DEVELOPMENT REVIEW BOARD REPORT

Desert Summit Lot 34 - Building Envelope 12-PP-1995#2	Request for approval to modify the previously approved building envelope for Lot 34 of Desert Summit, as established through 12-PP-1995, for a +/- 2.0-acre property.
--	---

12-PP-1995#2

BUILDING ENVELOPE AND NAOS PLAN

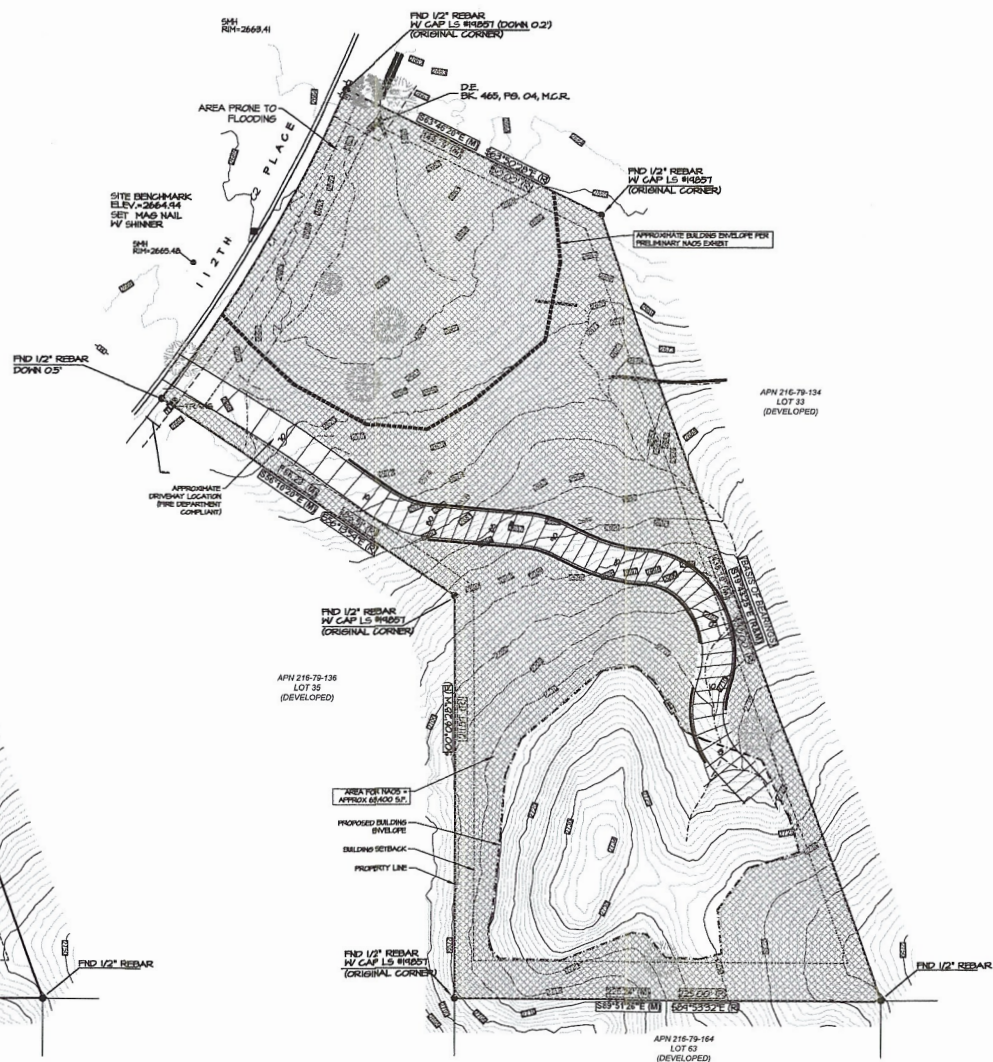
- *Staff finds that the Desert Summit zoning stipulations (76-ZN-1992 & 76-ZN-1992#2) established that building envelopes would be required for each lot and directed the implementation of those envelopes to the Preliminary Plat and Final Plat processes. The Preliminary Plat approval (12-PP-1995) and associated Natural Area Open Space (NAOS) Plan directed that the area outside of the building envelopes be maintained as NAOS and comply with the zoning stipulated minimum dimensional parameters between envelopes. This proposal seeks to modify the envelope location for Lot 34 more significantly than other deviations seen in the surrounding lots and in conflict with the stated purpose of the Environmentally Sensitive Lands (ESL) ordinance and its NAOS preservation and location guidelines. The purpose statement of the ESL (Sec. 6.1011) specifies intentions that include but are not limited to the following:*

development from encroaching into the portion(s) of the subdivision with Hillside landform designations and Conservation Area easement protection. With the exception of adjacent Lot 35, the other lots surrounding the Hillside landform boundary have developed with limited encroachments. The modified building envelope location proposed for Lot 34 does not appear to align with the implicit purpose behind the current building envelope positioning or the protection of the hillside slopes and significant natural features of this lot and those surrounding the Hillside landform boundary and Hillside Conservation easement area.

SITE PLAN
SCALE 1"=30'-0"

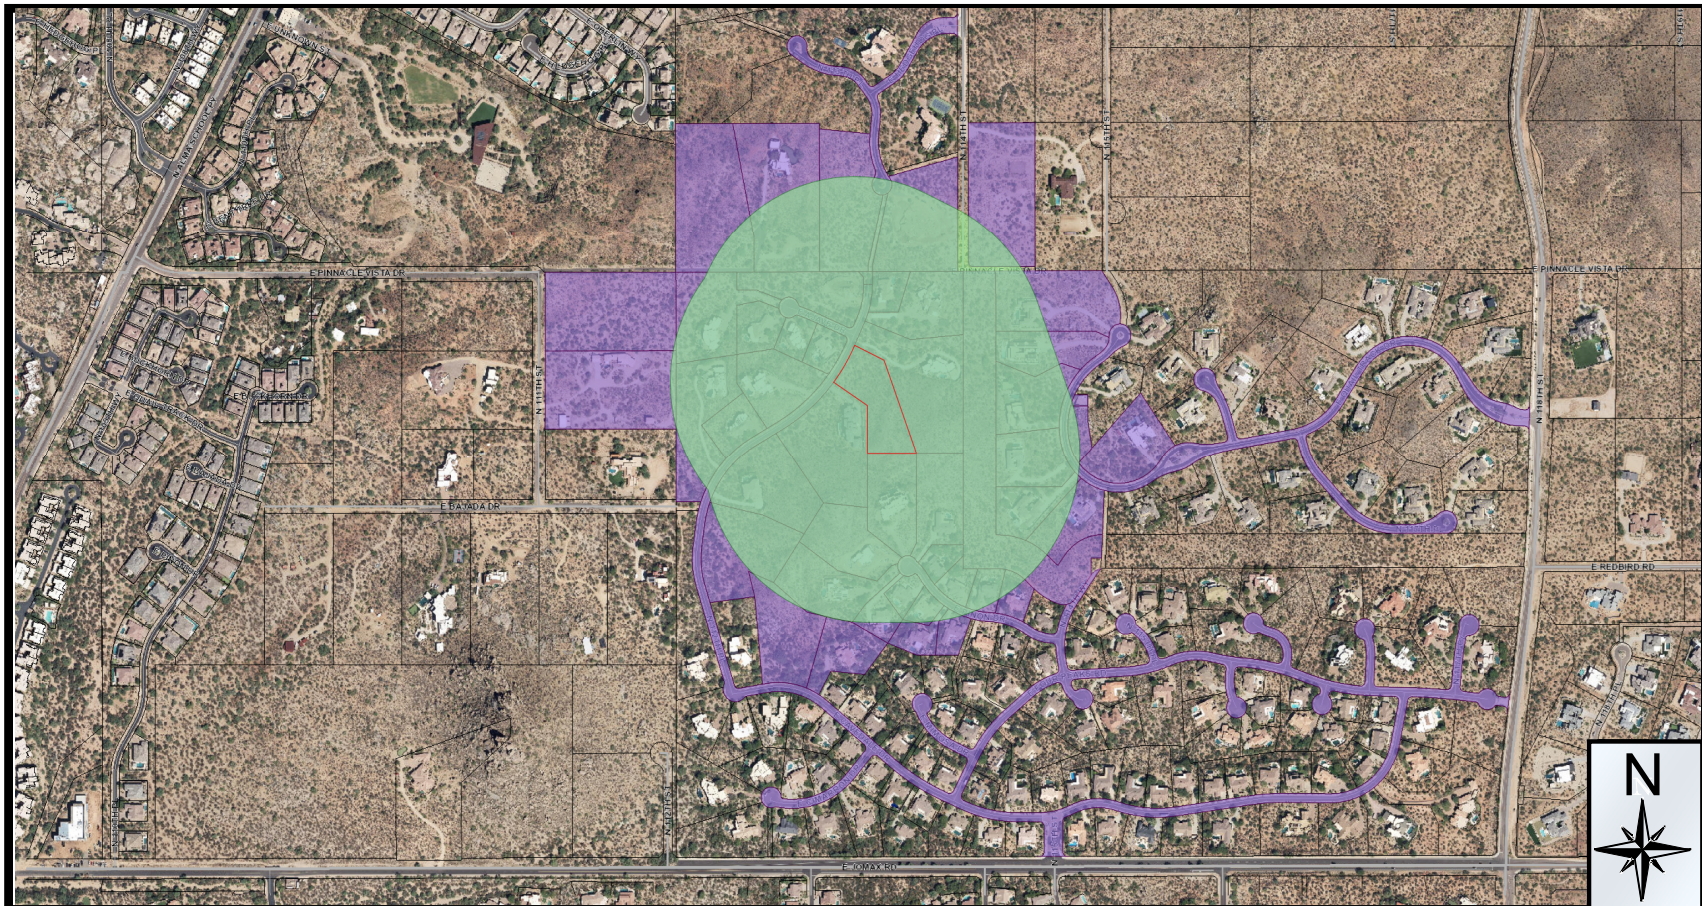
The proposed envelope location for Lot 34 also does not appear to achieve the minimum 60-foot separation stipulation when measured to the constructed location of the home and associated improvements on adjacent Lot 35. There is no clear specific approval record for the modified building envelope location of Lot 35 as it exists today beyond the site plan approval record for the permitting of that house in 2020. The retaining wall improvements on Lot 35 sit 15-20 feet setback from the shared boundary between Lots 34 and 35. The proposed building envelope location on Lot 34 appears to similarly be setback around 20 feet, achieving only an approximate 40 feet separation between the two building envelopes.

- *Staff finds the modified building envelope location proposed for Lot 34 requires additional driveway length and pavement to provide access to the higher elevations of the lot, farther away from the street than the current envelope. That change in positioning results in more driveway related disturbance through the lower portions of the lot and extending up the hillside, and less protection/preservation of the more significant natural features of the upper portion of the lot as directed within the purpose of the ESL overlay.*

Continue the proposal to allow the applicant to seek an alternative building envelope location/configuration.
